#### Certificate of Appropriateness

1911 N. 2ND ST. **Brewers Hill**

PTS ID 115001 COA: remodel & side porch

# HISTORIC PRESERVATION COMMISSION REVIEW SUBMISSION

Proposed fence design. Lattice is optional for any fence section less than or equal to 48" in height.

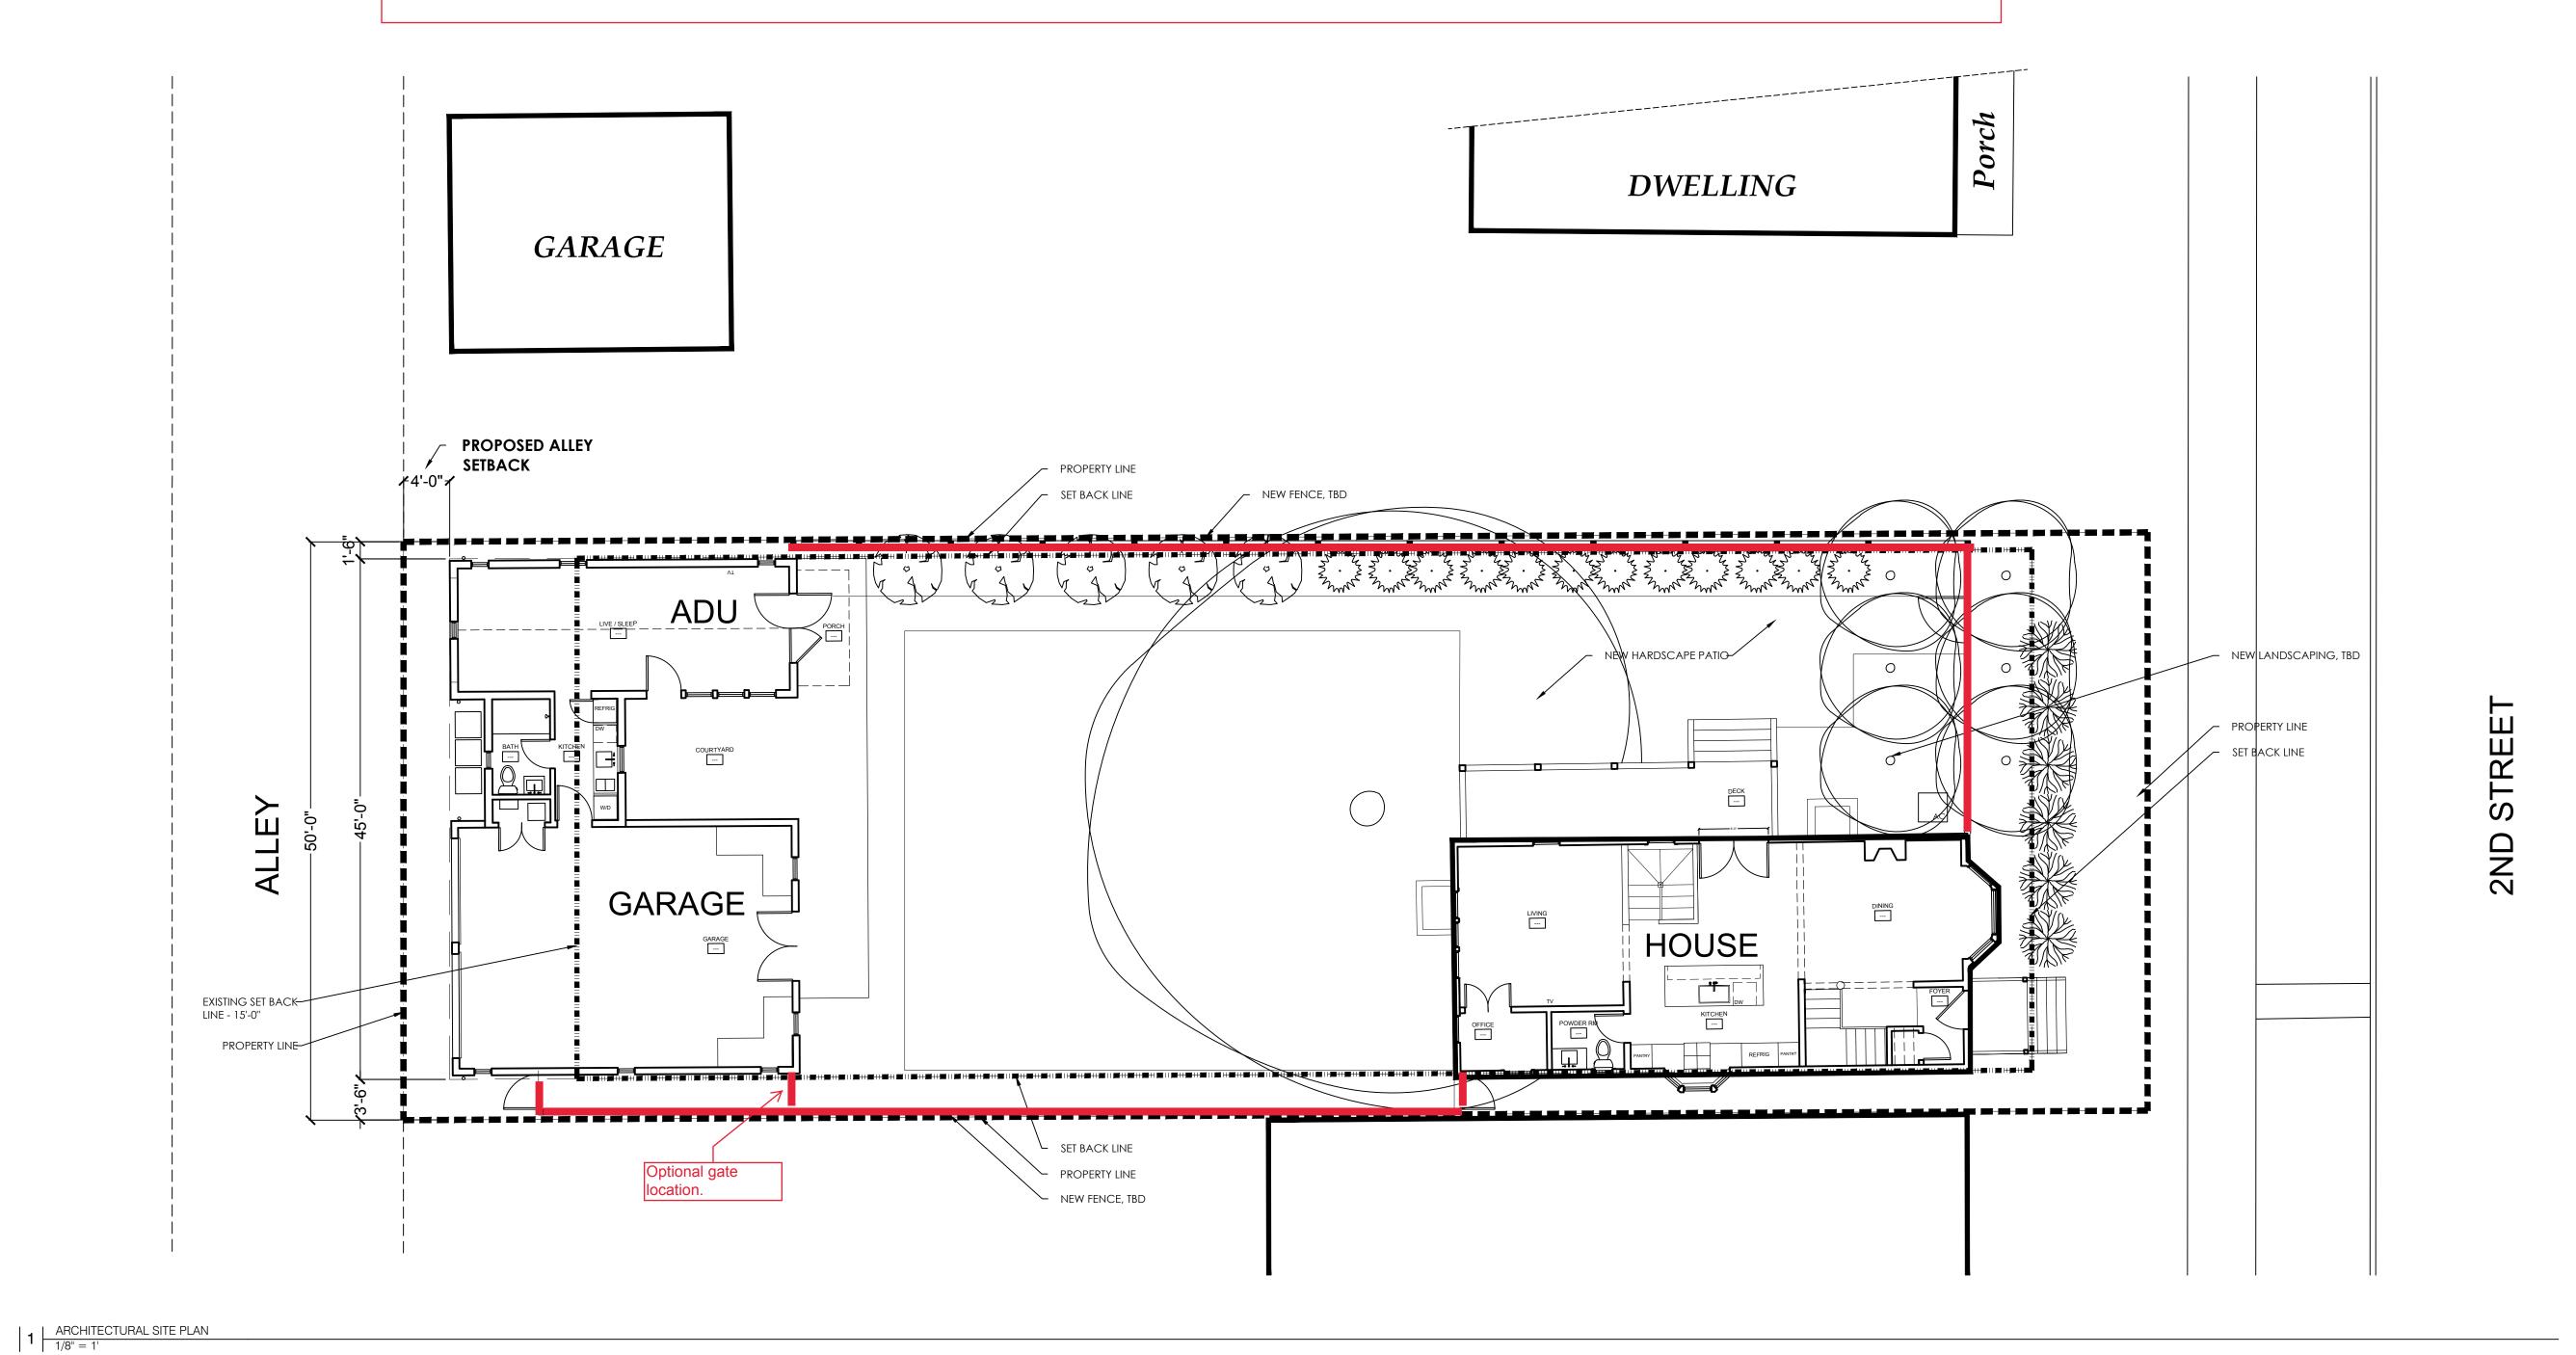
- **Description of work** 1. Replace side entrance new French doors and with larger side porch
  - 2. Remove rear exterior staircase and restore jump porch
  - 3. Add rear egress window from basement
  - 4. Fencing with board and lattice design (Living With History, p. 88), with zoning compliant heights. Disregard landscape plan beyond fencing and alley access to new garage
  - 5. Add windows on north and west elevations
  - 6. Add skylights to rear of north roof slope

Board and lattice, also called a "treillage fence"

EXISTING / DEMO EXTERIOR ELEVATIONS

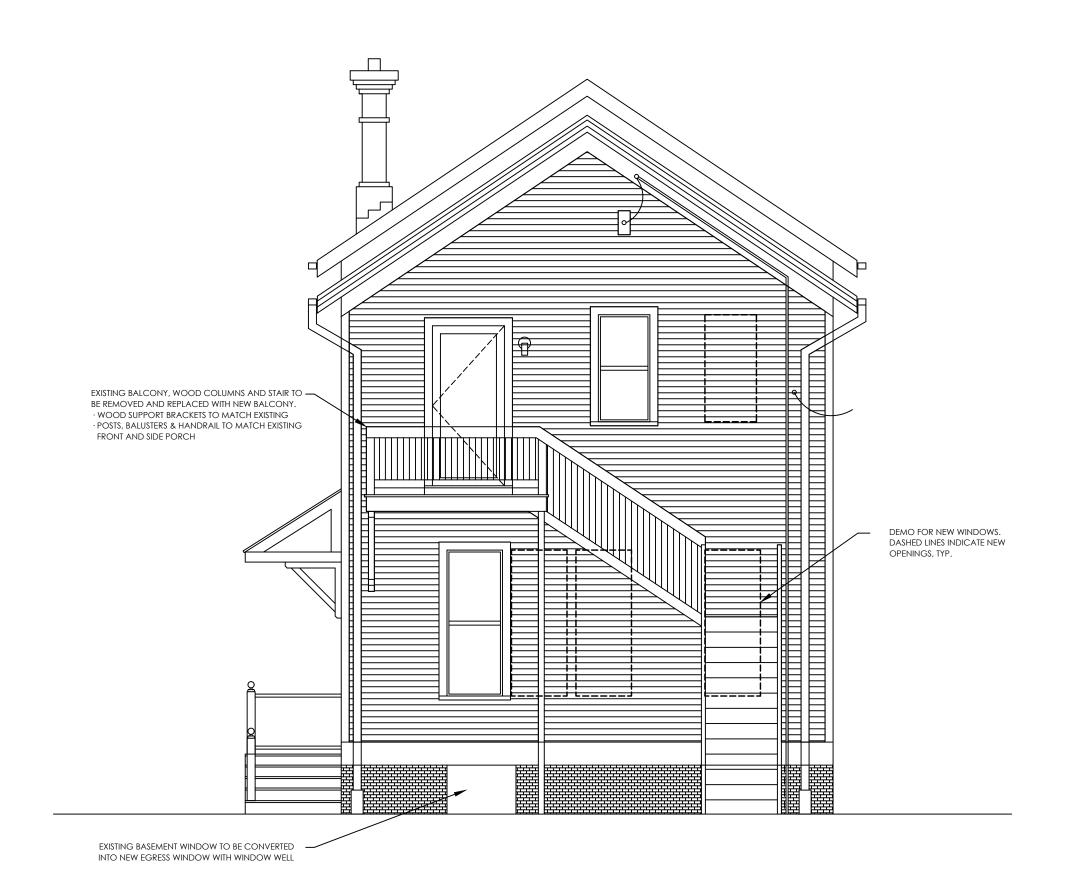
DEMO FOR NEW SKYLIGHT EXISTING WINDOW OPENING TO BE ENLARGE FOR NEW WINDOW NEW WINDOW & DOOR OPENINGS TO MATCH EXISTING TRIM SIZES & PROFILES EXHAUST VENT TO BE REMOVED - DEMO EXISTING WINDOW EXPOSED MECHANICAL CHASE TO BE DEMO FOR NEW WINDOWS. DASHED LINES INDICATE NEW OPENINGS, TYP. EXPANDED OPENING FOR NEW FRENCH DOOR — ROOF & STOOP TO BE REPLACED WITH — NEW COVERED SIDE PORCH THAT
MATCHES EXISTING SIDE PORCH & FRONT APPROVED By Tim Askin - Milwaukee HPC at 2:38 pm, Mar 18, 2022

EXTERIOR ELEVATIONS A3.0

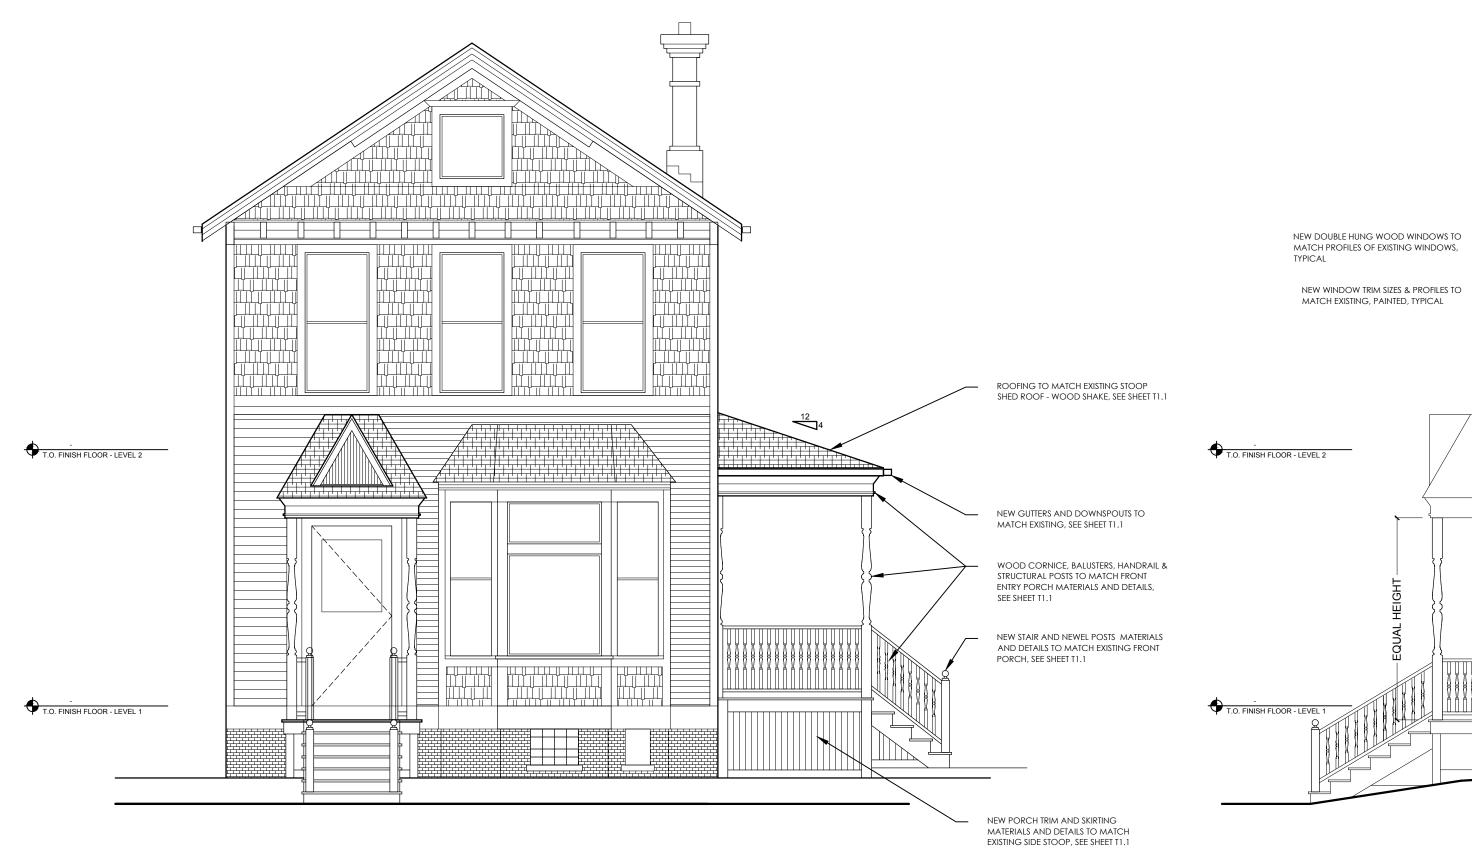
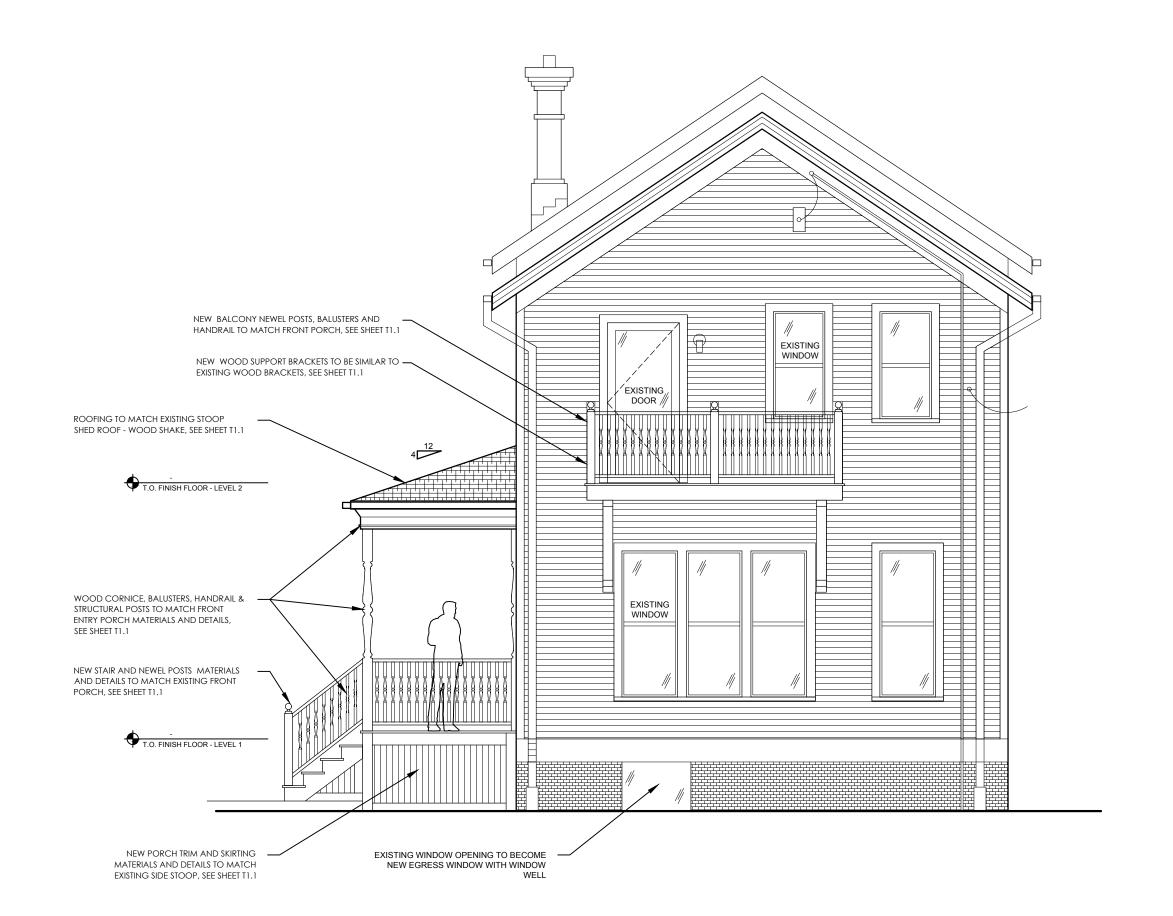
ROOFING TO MATCH EXISTING STOOP SHED ROOF - WOOD SHAKE, SEE SHEET T1.1

STRUCTURAL POSTS TO MATCH FRONT ENTRY PORCH MATERIALS AND DETAILS, SEE SHEET 11.1

NEW PORCH TRIM AND SKIRTING MATERIALS AND DETAILS TO MATCH EXISTING SIDE STOOP, SEE SHEET T1.1

NEW BALCONY NEWEL POSTS, BALUSTERS
AND HANDRAIL TO MATCH FRONT

— NEW WOOD SUPPORT BRACKETS TO BE SIMILAR TO EXISTING WOOD BRACKETS, SEE SHEET T1.1

NEW WOOD FRINCH BRITISY DOOR.
GLAZING SILL TO MATCH ADJACENT
WHOOD OF PRINCH BRITISY DOOR.
GLAZING SILL TO MATCH ADJACENT
WHOOD SILL HEGHT
